DESIGN TEAM RESPONSES TO 12TH & MENAUL COMMITTEE LETTER DATED APRIL 2, 2014

A letter with attached comments was submitted by the 12th & Menaul Committee on April 2, 2014 to the City of Albuquerque Design Team. Refer to the letter to correlate the responses with the comments. Following are the Design Team's responses to the letter.

Schematic of a Revised Roundabout Concept

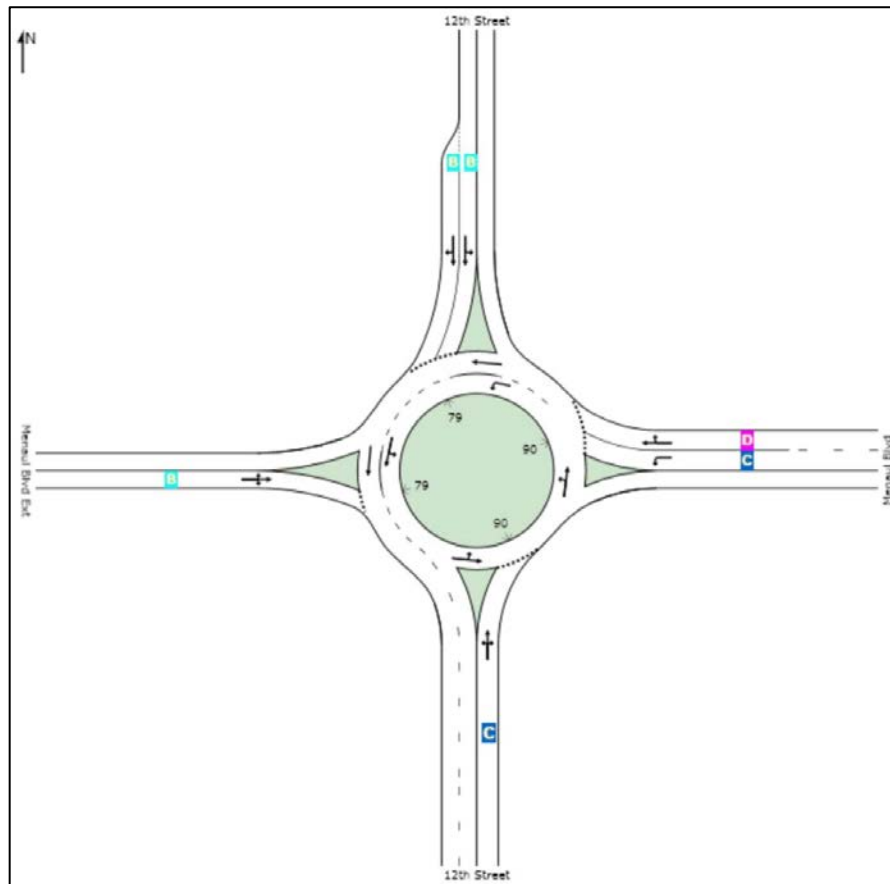
Roundabout Option for 12th/Menaul

The roundabout design details will be refined in final design, and it will be designed so that buses will not be required to use the truck apron to navigate the roundabout. A schematic of a revised roundabout configuration proposed by the City is provided below. To function acceptably, two entry lanes are needed on 12th Street from the north. This two-lane entry is the only variation required from the 12th & Menaul Committee comment.
